MONTGOMERY COUNTY PLANNING DEPARTMENT
THE MARYLAND-NATIONAL CAPITAL PARK AND PLANNING COMMISSION

MEMORANDUM

SUBJECT: Worksession #6 – Wheaton Central Business District (CBD) and Vicinity Sector Plan: Continuation of Land Use and Zoning – Districts and Parcel Specific Issues, and Urban Design Guidelines.

Kensington View/Wheaton Hills District

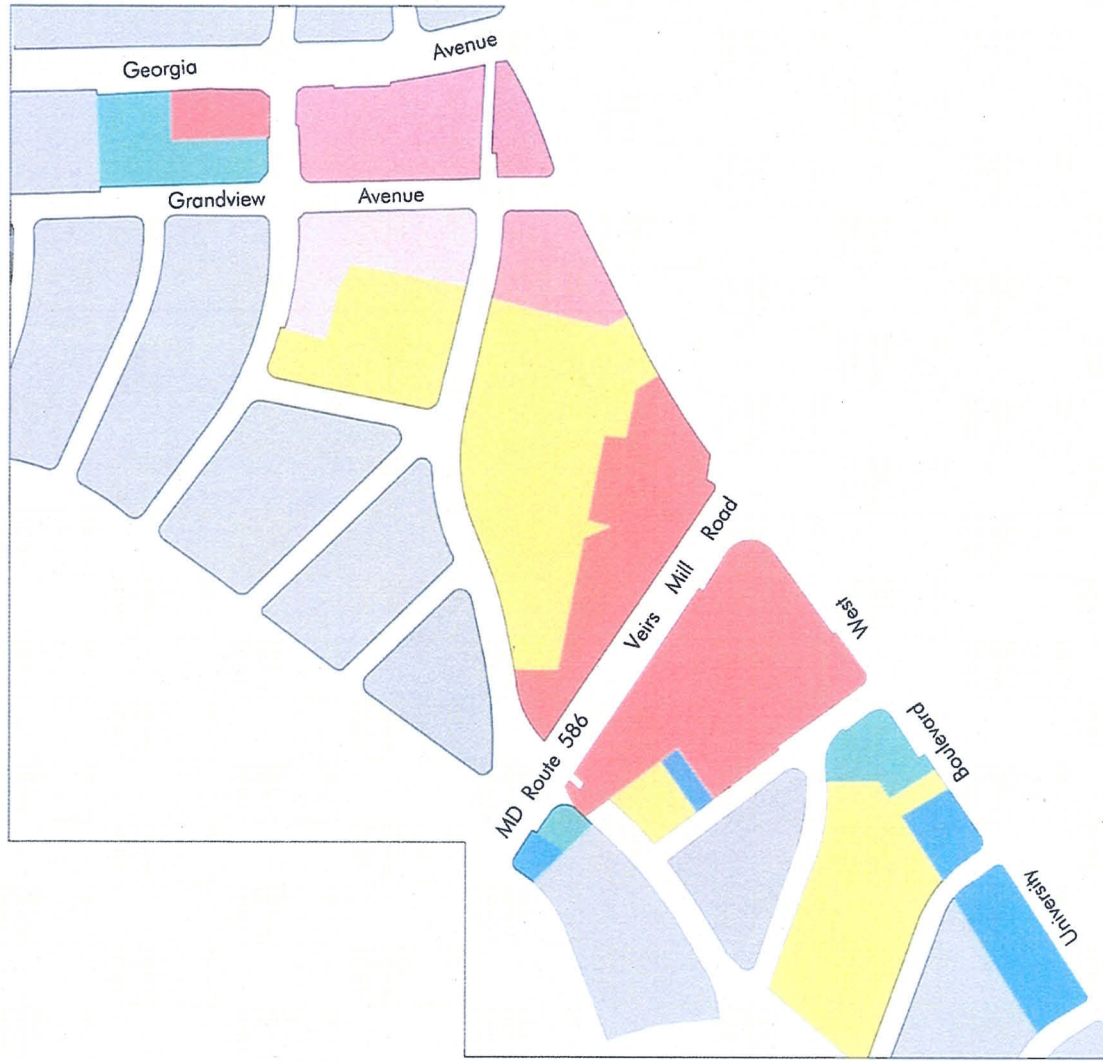
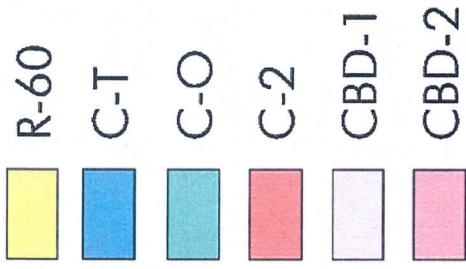
The CRN zone is appropriate for currently commercial and residentially zoned properties along University Boulevard between East Avenue and Valley View Avenue. The proposed CRN zone recommends maximum height and density that is compatible with neighboring residential properties allowing low intensity transitional mixed-use development between single-family residential zones in the Kensington View neighborhood and commercial uses across University Boulevard on the Westfield Mall property site. (See circle pages 4a and 4b).

1. Rezone lots 7, 23, 22, and lot labeled PT-1 on Block X and lots PT-6, PT-7, and PT-8 on Block Y on University Boulevard, (page 39 of the Draft Plan) from C-T to CRN 1.5: C 0.5, R1.5, H 45'. Include text in the Draft Plan to note that residential or professional townhouse development would be appropriate on these sites.
2. Rezone lot PT-5 on Block Y (page 39 of the Draft Plan) from R-60 to CRN 1.5: C 0.5, R 1.5, H 45'. Include text in the Draft Plan to note that residential or professional townhouse development would be appropriate on these sites.
3. Rezone lots 29 and 28, and PT-3 and PT-4 on Block Y (page 39 of the Draft Plan) from C-O to CRN 1.5: C 0.5, R 1.5, H 45'. Include text in the Draft Plan to note that residential or professional townhouse development would be appropriate on these sites.

Kensington View/Wheaton Hills District
Proposed Zoning Changes

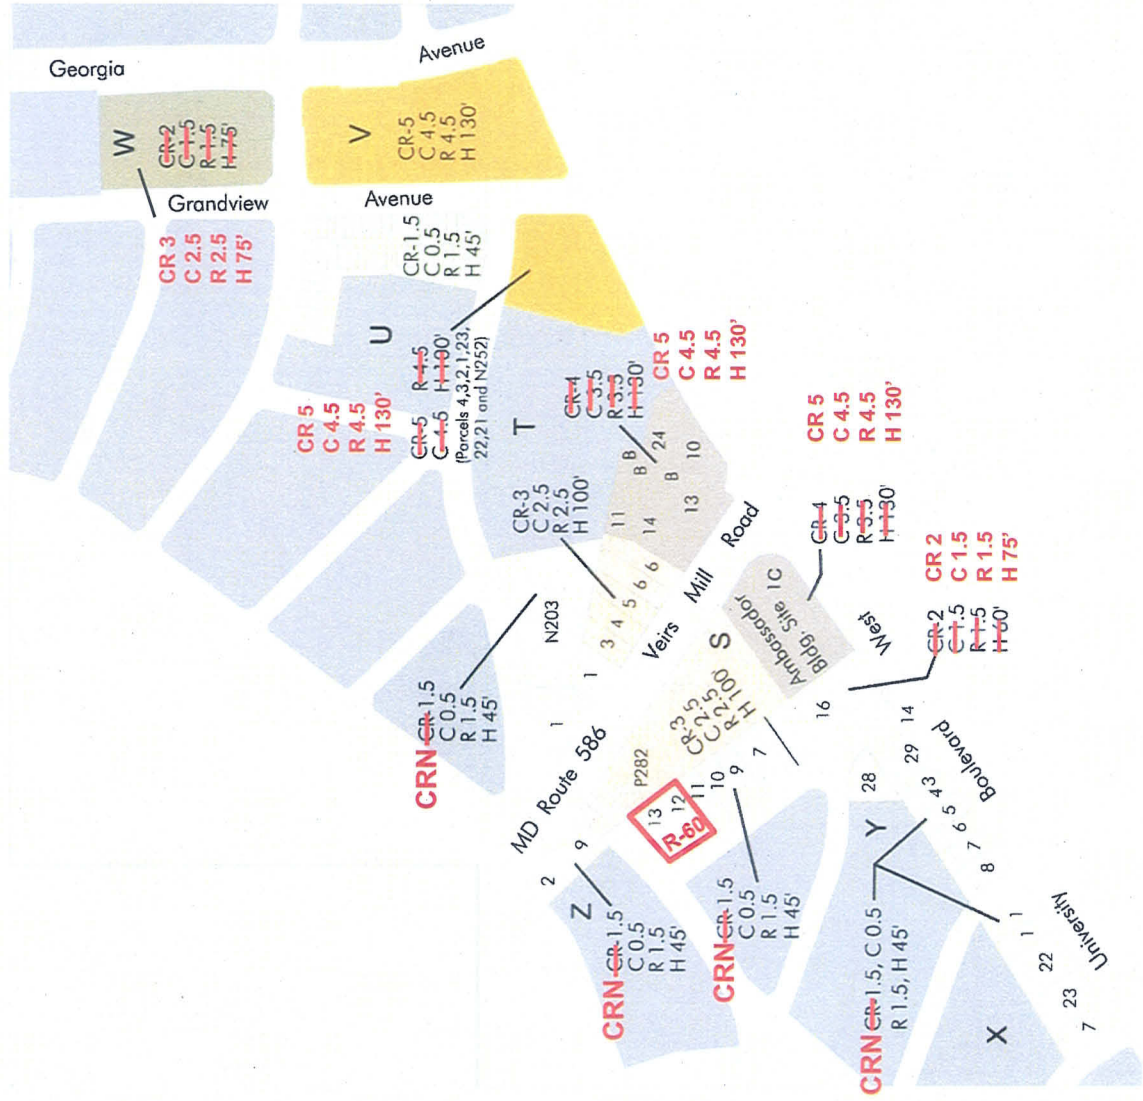
4. Rezone lots 2 and 9 on Block Z (page 39 of the Draft Plan) from C-O and C-T to CRN 1.5: C 0.5, R 1.5, H 45'. Include text in the Draft Plan to note that residential or professional townhouse development is appropriate on these sites.

Along the east side of East Avenue (Block S), (page 38 of the Draft Plan) the properties currently zoned C-T and C-2 are appropriate for the CRN Zone.

Westfield Wheaton Mall Property

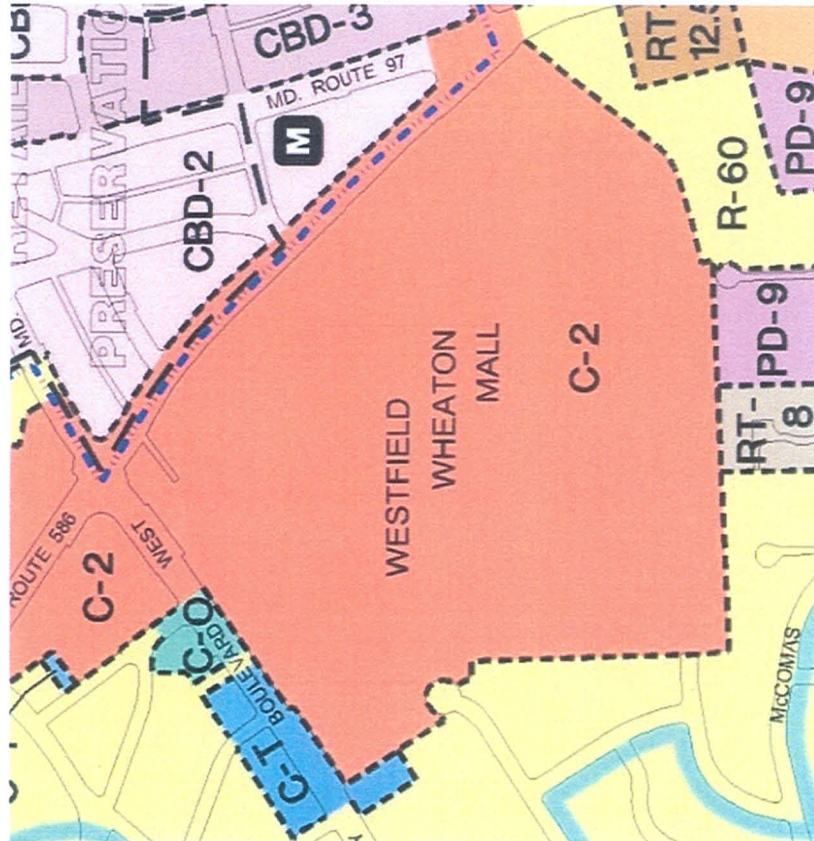
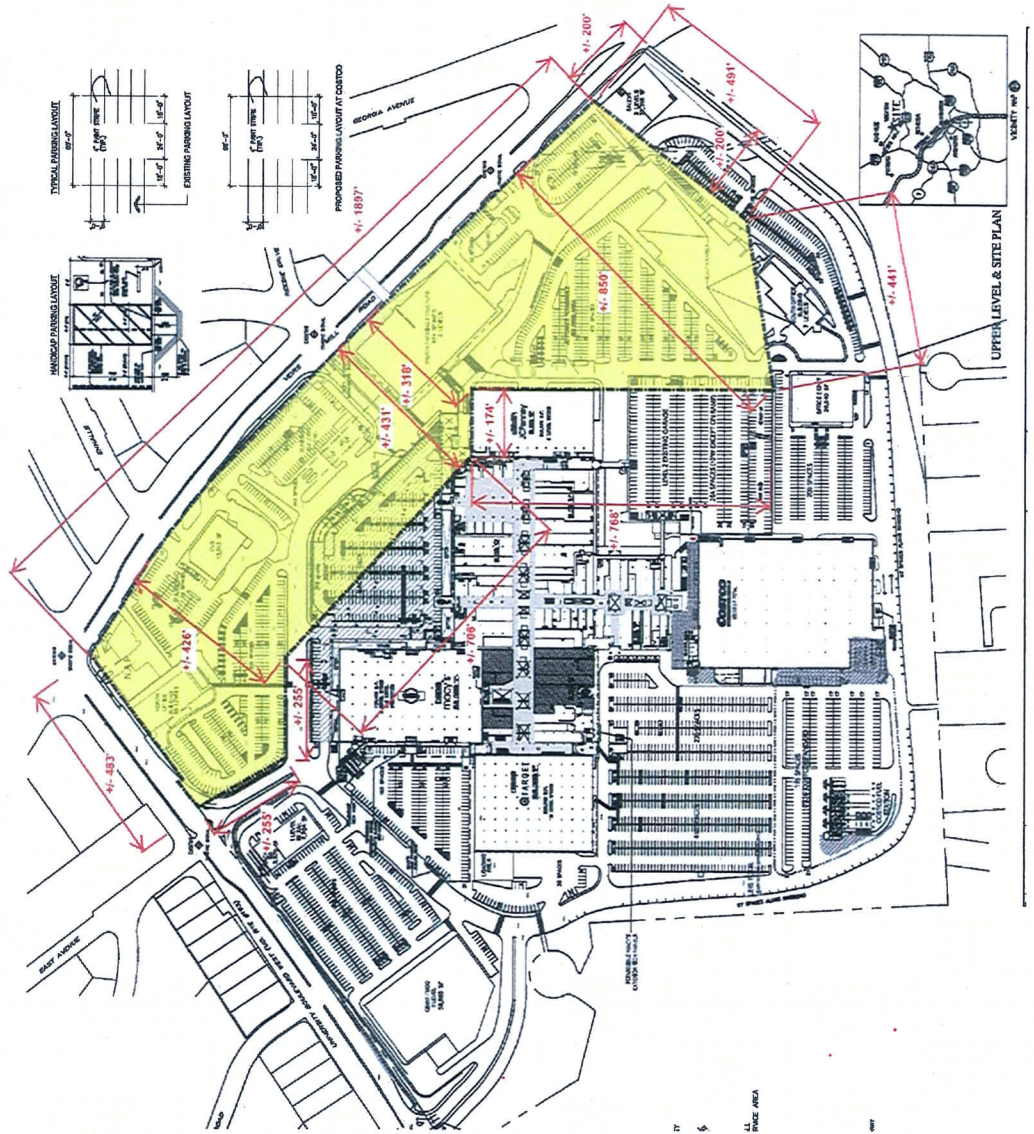
Staff has worked with the Wheaton Mall representatives to redefine the boundary of the proposed CR 6 Zone along the Veirs Mill Road side of the property to create a slightly larger area than originally proposed in the Public Hearing Draft Plan for the proposed CR 6 designation. Westfield's conceptual plans for a possible mixed-use development on that part of the mall property helped to inform this vision. The revised boundary is also more clearly delineated and measureable as it will create a split-zone condition on the property. (Attached circle page 7b).

The Public Hearing Draft Plan recommended rezoning the central core of the mall site to CR 3: C 1.5, R 2.5, H 75' (page 37). Working with the Wheaton Mall representatives and reviewing the application of the CR Zone to the entire Wheaton Mall property, staff has concluded that certain CR Zone standards cannot be applied on the Mall property without further interpretation of these provisions. For example, the CR Zone requires buildings to be oriented to the street frontage but there is no "street frontage" for the core mall structure. Similarly, requiring ten percent open space on a site that is

Change the maps and text in the Draft Plan on page 37 to reflect the revised rezoning recommendations (see circle page 8a).

Include new text to emphasize the need for maintaining the existing buffer along the southern edge of the property abutting the residential community and emphasize that any rezoning of the C-2 portion of the mall site in the future must maintain a green buffer and provide an appropriate building height transition.

Price District Proposed Zoning Changes

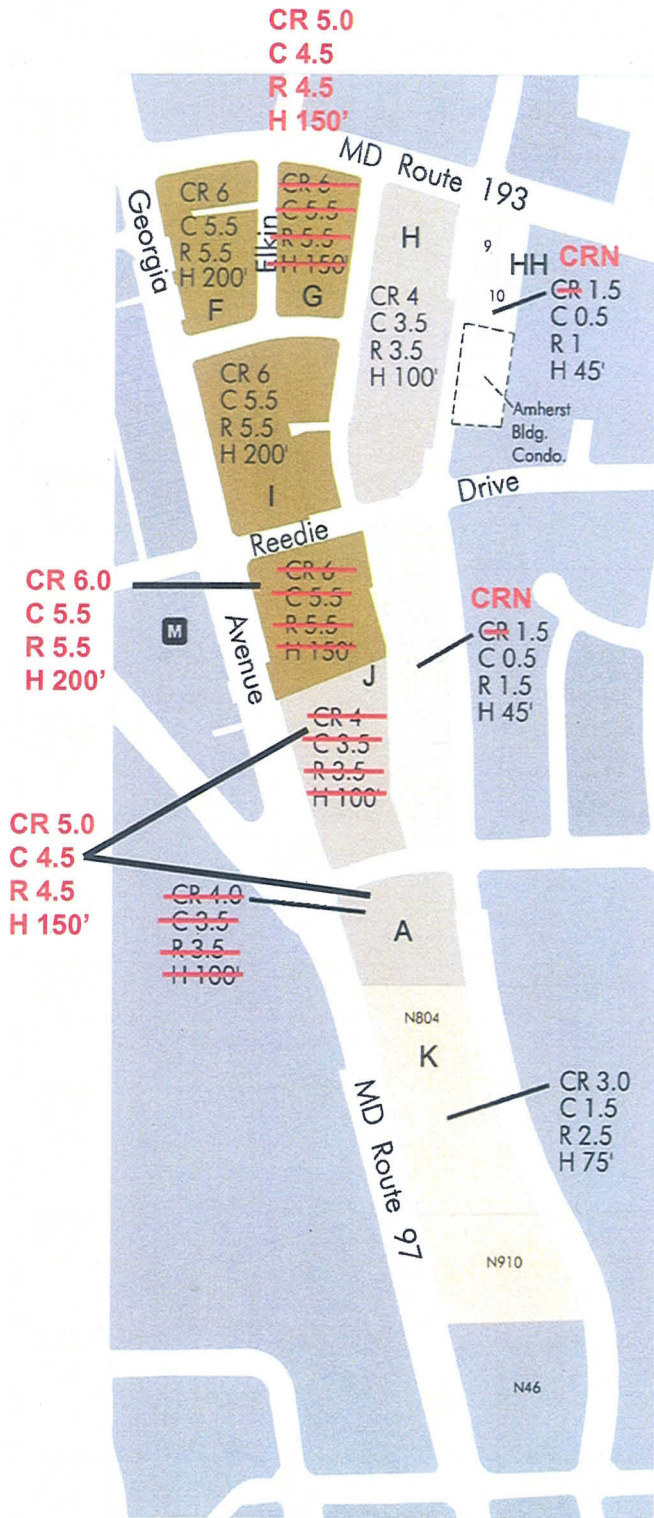
The Draft Plan recommends that this northern half of this block be rezoned from CBD-3 to CR6: C5.5, R5.5, H150. The staff now recommends that this site be rezoned to CR 6.0, C5.5, R 5.5, H200 to be consistent with the recommended rezoning on other blocks surrounding the WMATA Triangle, which has a maximum permitted building height of 250 feet.

The Draft Plan recommends rezoning the southern portion of Block J from C-2 to CR3: C1.5, R2.5, H75. Staff now recommend rezoning this southern portion to CR3: C2.5, R2.5, H75 to allow greater flexibility in the development of this site by increasing the allowable commercial FAR from 1.5 to 2.5.
